Massachusetts Institute of Technology
C. S. Draper Laboratory
Cambridge, Massachusetts

LUMINARY Memo #148

To: Distribution
From: B. McCoy
Date: 11 May 1970
Subject: Call It LUMINARY 1D

Revision 163 of Luminary was released on 5/5/70 for manufacture. It contained a total of 39 PCRs, 6 PCNs, 15 ACBs and 6 Anomalies. On the following pages is a detailed description of each implementation or a reference made where appropriate.

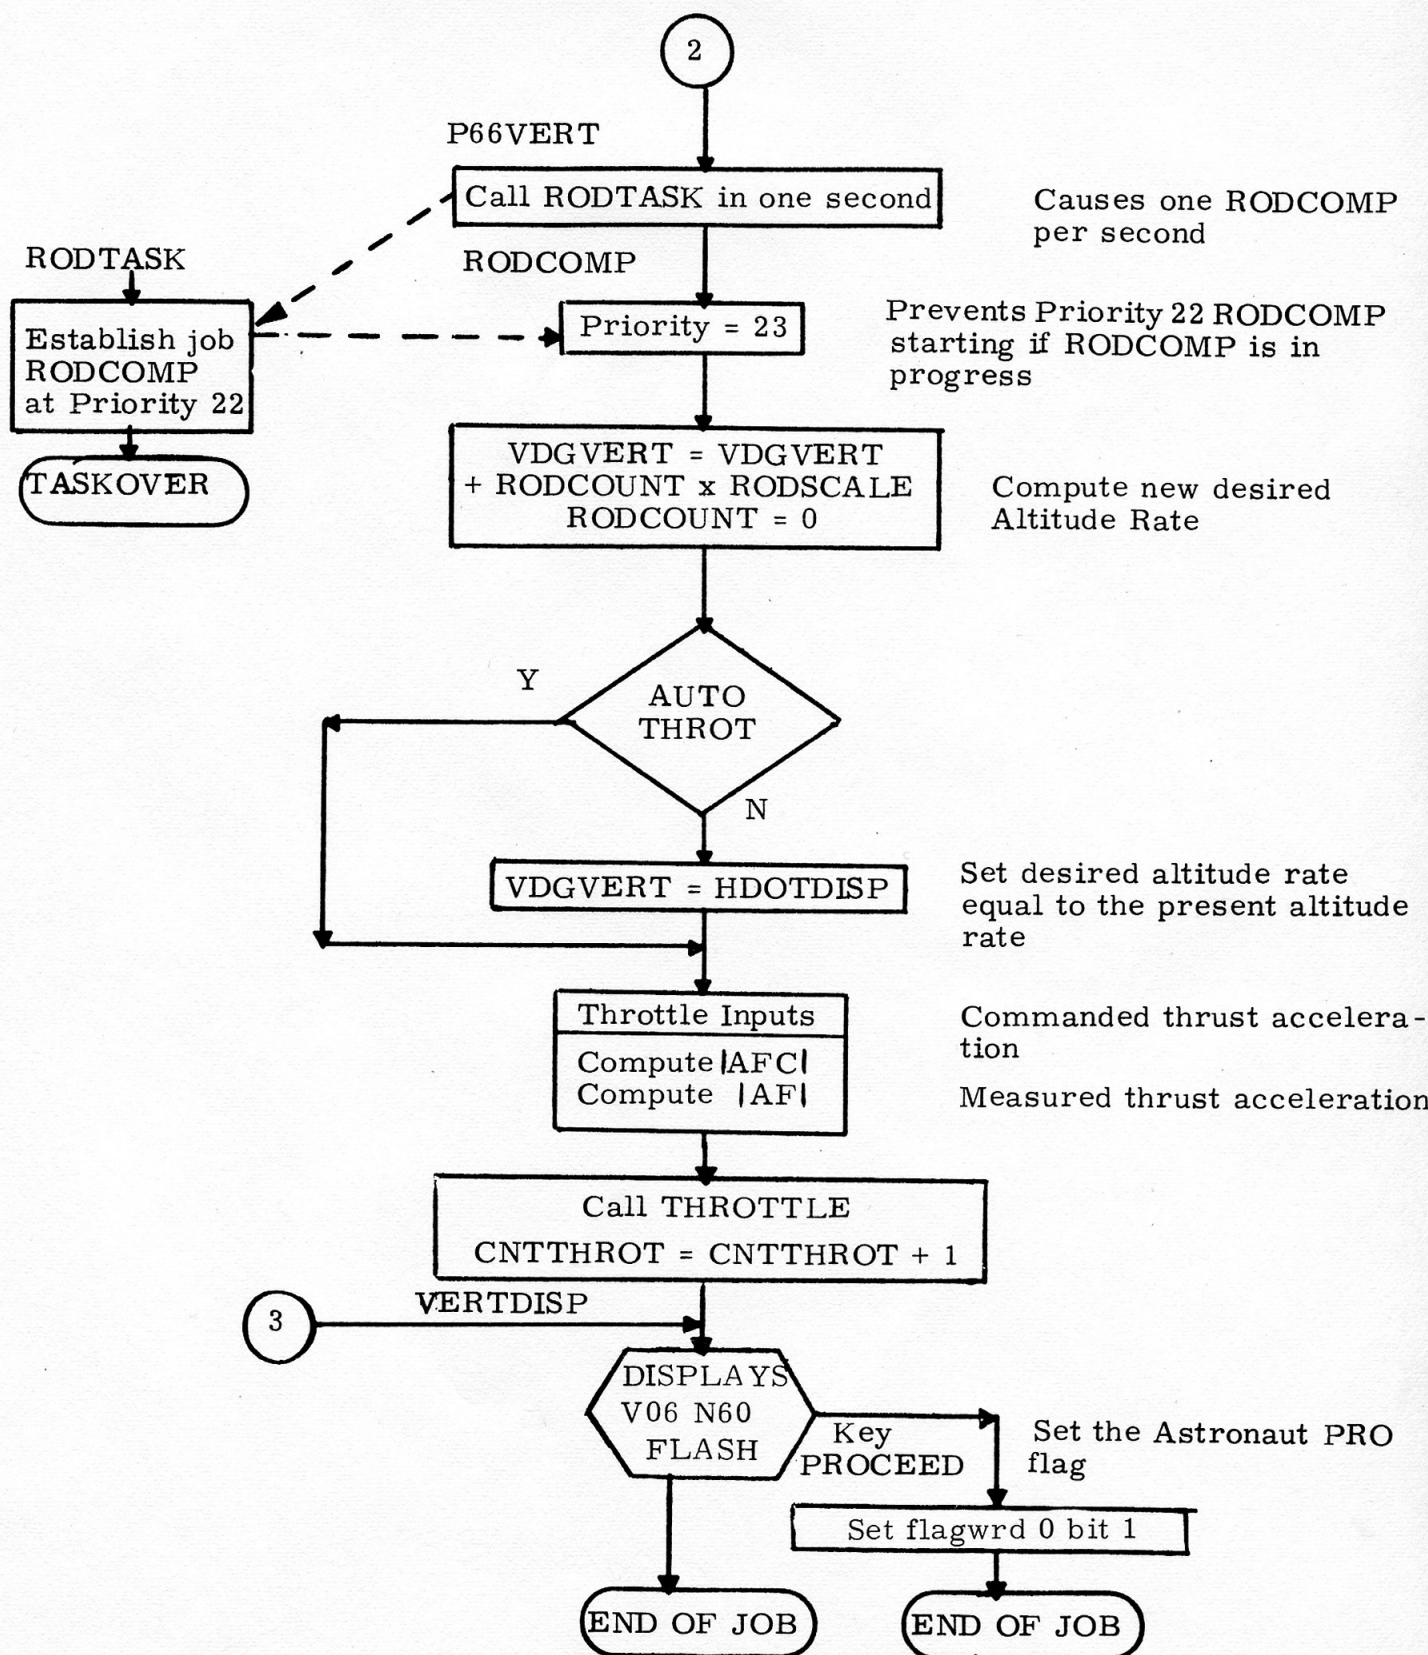
- 986.2 Fixed Memory Ephemeris constants were updated to 1970-1971 year.
- 988/1037/1035 P66 is essentially the same as it was in Luminary 1C (LM131 rev 1) which was done so as to keep changes only in one rope module for the re-release of Luminary 1C. Differences: a PRO to the V06N60 sets P66PROFL (Flagwrd 0, bit 1). This inhibits FINDCDU from sending RCS commands if the ENGARM switch is off. PCN 1037 removes a "Stoprate" and the resetting of REDFLAG (Flagwrd 6 bit 6) from P66 initialization. It also adds a "Stoprate" when a 01466 alarm occurs. Therefore should the situation arise via high TLOSS etc, that P66 is having difficulty in emitting sufficient throttle commands, a 1466 alarm will occur preceded by RCS jet activity to stop any vehicle rates. PCN 1035. The Terrain Model will be terminated when P66 is started; NOTERFLG (Flagwrd 1, bit 11) is set which causes Servicer to bypass Terrain Model computations.

--Has Proceed been keyed in response to
Flashing V06 N60 ?

* GHZ is lunar gravity; QHZ and $1/\text{TAUHZ}$ are gain constants; VY and VZ are the Y and Z components of velocity, platform coordinates VHZCY and VHZCZ are the Y and Z components of commanded velocity, platform coordinates; I-1 indicates the previous pass, and on the first P66 pass this indicates the final P64 pass. (LIMIT AHZLIM) indicates the content of the subsequent parentheses is magnitude limited to AHZLIM.

1025

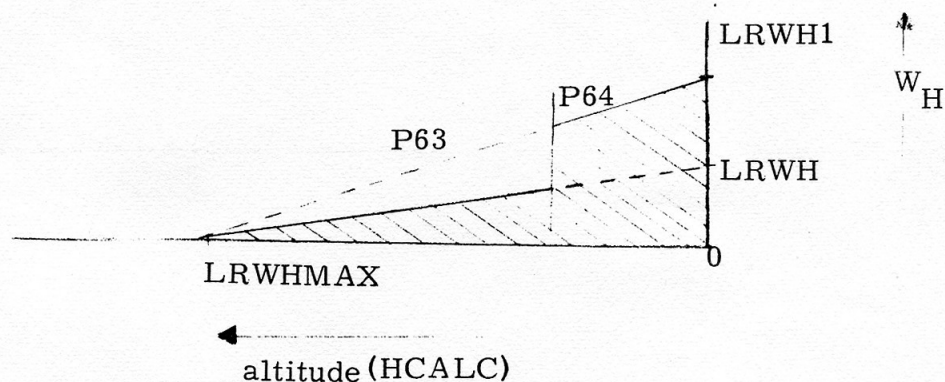
The LM navigated state vector was updated for any gravity effects on altitude after the LR updates. This was deemed to be insignificant and was removed. A call to MUNGRAV was removed from routine RVBOTH.

1028/1039

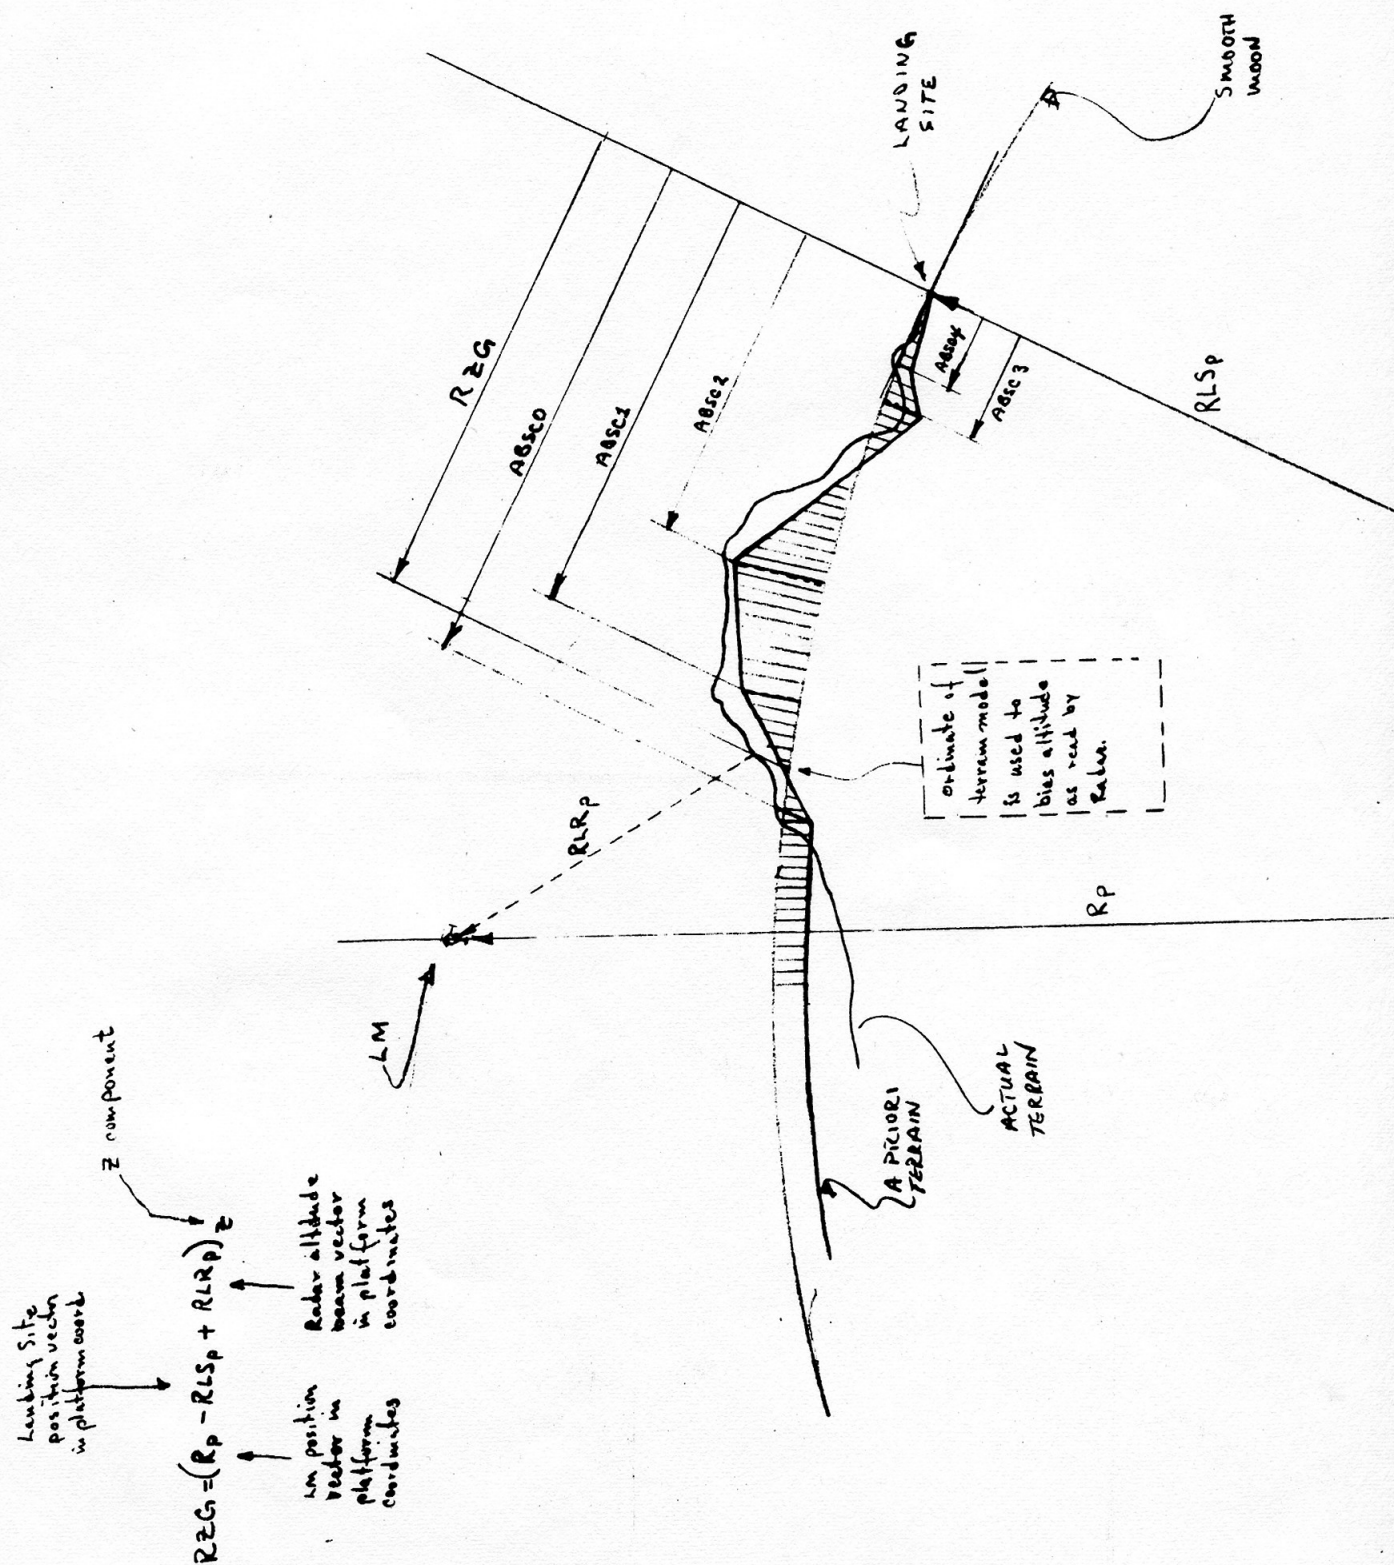
A new padload (LRWH1, E7, 1756) was created to allow for a two-segmented altitude weighting function. The present scheme is as shown below.

given by equation $W_H = LRWH (1 - HCALC/LRWHMAX)$.

LRWH is set equal to LRWH1 in P64.

W_H is altitude weighting function.

LRWH, LRWH1, and LRWHMAX are erasable to set the slope. HCALC estimated altitude.

A PRIORI TERRAIN MODEL

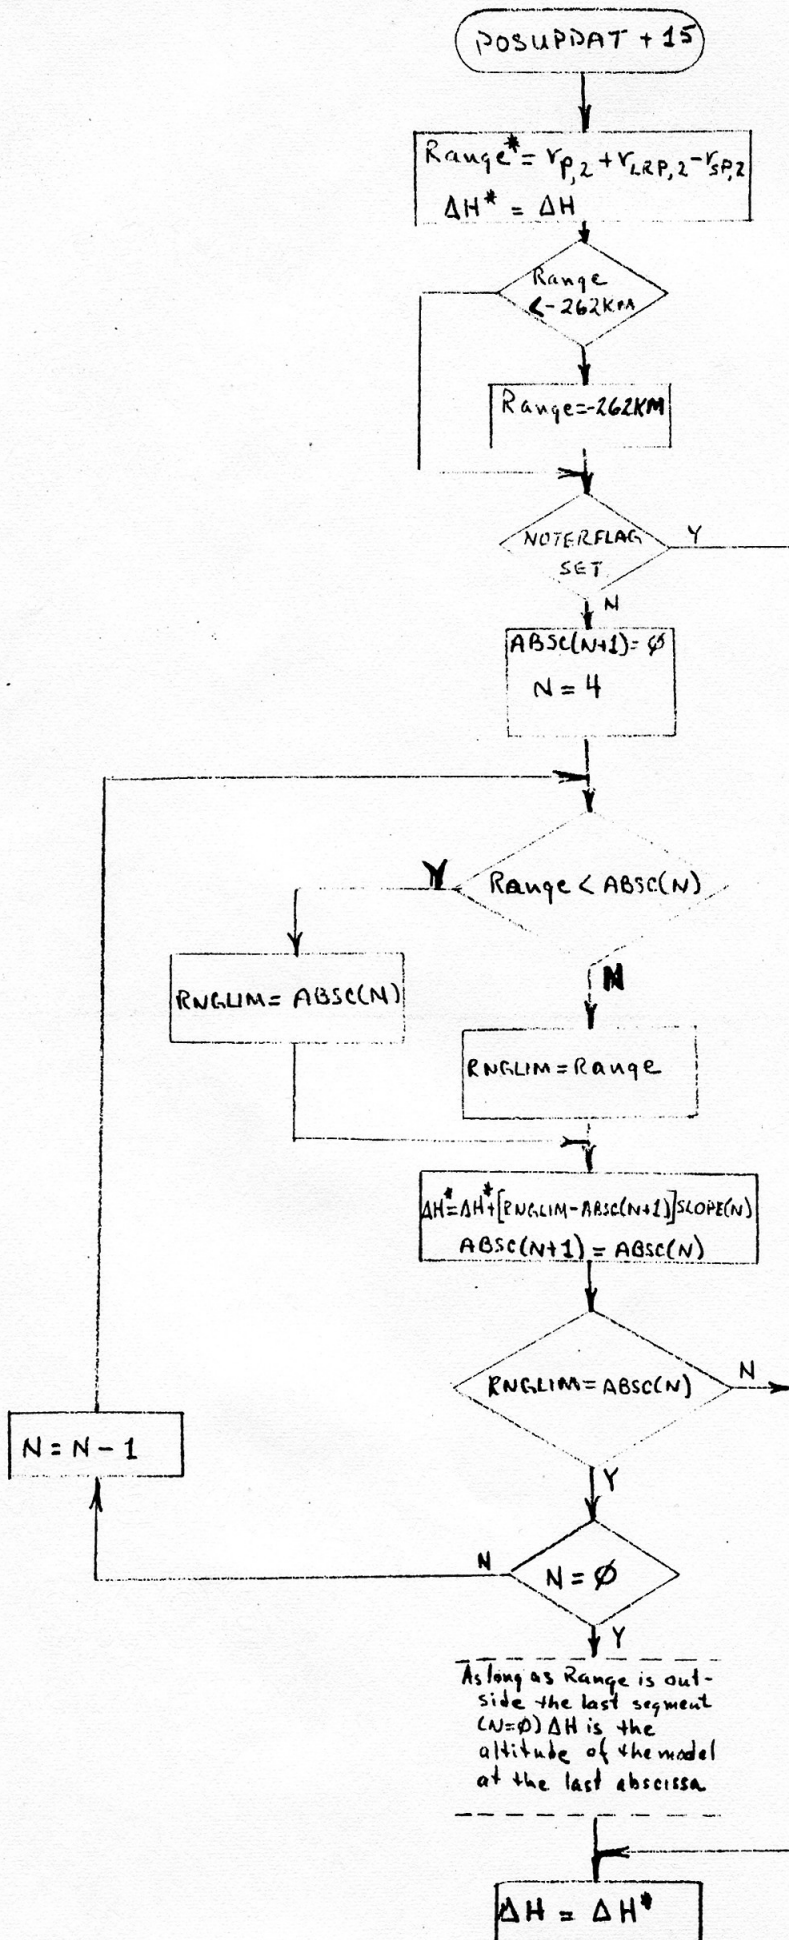
An a priori Terrain Model was implemented into Luminary to smooth the trajectory over rugged lunar terrain and to reduce the LPD errors and fuel consumption. It uses 5 segments, a slope and a range-to-landing site (abscissae), for each. The terrain not falling into the segmented region

(the model covers a region from some specified abscissae (range) to the landing site) will be modelled by a constant altitude, equal to the altitude at the last abscissae. The slopes and abscissae are specified in E memory by SLOPE0, 1, 2, 3, 4 and ABSC0, 1, 2, 3, 4. SLOPE~~4~~ and ABSC~~4~~ correspond to the segment nearest the landing site (loc E5, 1527 and E5, 1522 respectively, scaled B-6 and B-18 respectively). For more details see Luminary Memo # by Allan Klumpp, Don Eyles, and Bruce McCoy. 147

L-1C-03

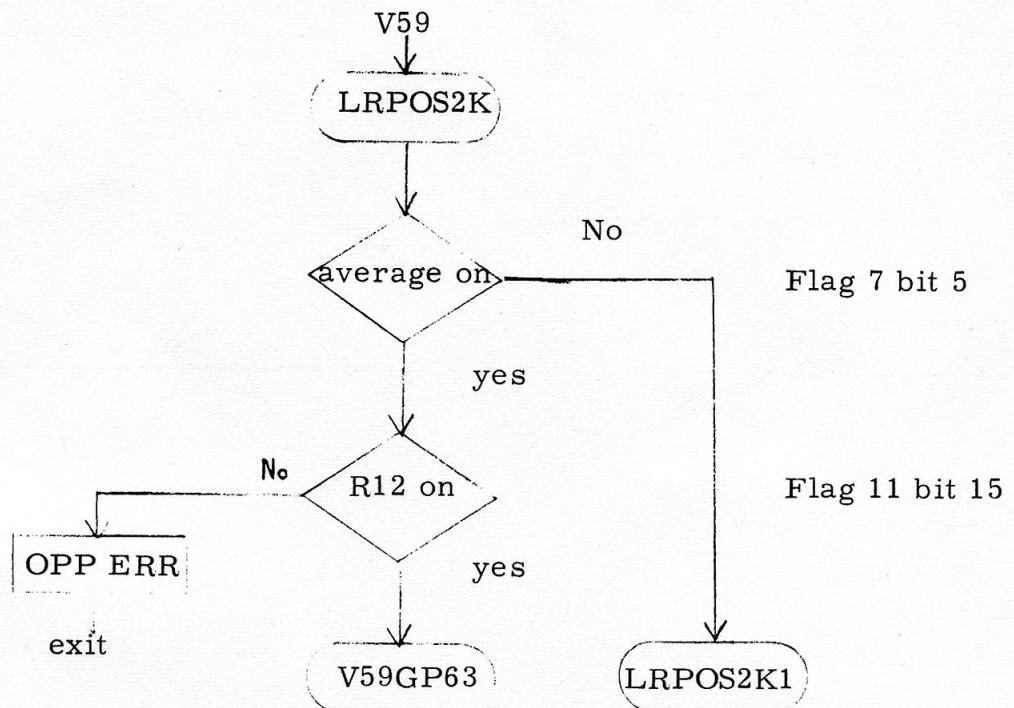
A coding error in V59 leadin caused the DAP estimated attitude errors to be placed on the FDAI needles as well as moving the LR antenna to position #2. It was rewritten as shown below:

Now, V59 can be used in P64 if desirable.
